**TRANSMITTAL OF MEETING HANDOUT MATERIALS FOR  
IMMEDIATE PLACEMENT IN THE PUBLIC DOMAIN**

To meet with Westinghouse to discuss construction

## INCONSISTENCIES NOTED WITH AP-600 DOCUMENTS

SFP Drawing:

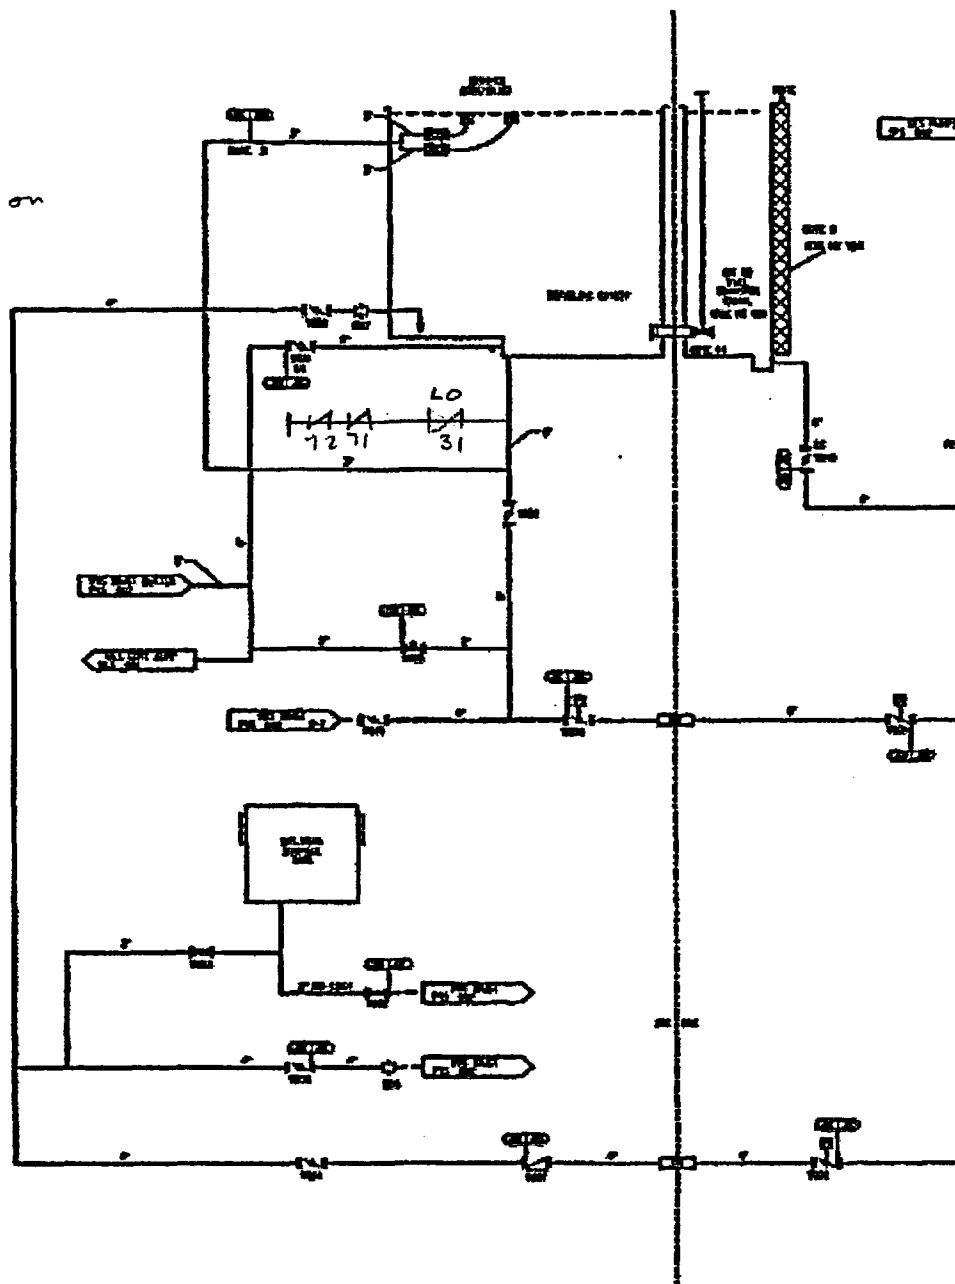
4. Tier 1 Figure 2.3.7-1, SFP Cooling, specifies that a number of pipe segments are classified ASME Section III but there is no listing of ASME components in Table 2.3.7-1. Most of the other sections list the system valves that provide the Code break change. (The drawing in the Tier 2 document does not include line numbers or Code break flags.) Shouldn't the valves be included in the Table?

5. Tier 1 Table 2.3.7-1 lists Line L030 as the Reactor Cavity Drain line but it appears that the line should be labeled Refueling Cavity Drain Line. The same condition exists in the AP-1000 Tier 1 DCD which has two lines (L030 & L040) listed Reactor Cavity Drain lines. The piping shown on the P&ID for both plants are connected to the refueling cavity. A new Section 9.1.3.3.8 was added to the AP-1000 SFS System Description that discusses a line from the Reactor Cavity to the Steam Generator Compartment but this is apparently a different line not shown on the P&ID. A new line with a LO manual valve and two check valves as discussed in 9.1.3.3.8 is shown on AP-1000 Figure 9.1-6 connected to the refueling cavity but its opposite end appears to be blank flanged. (The Reactor Cavity Volume for these designs is somewhat different than earlier designs and is shown on Figures 19.39-5 & 6.)
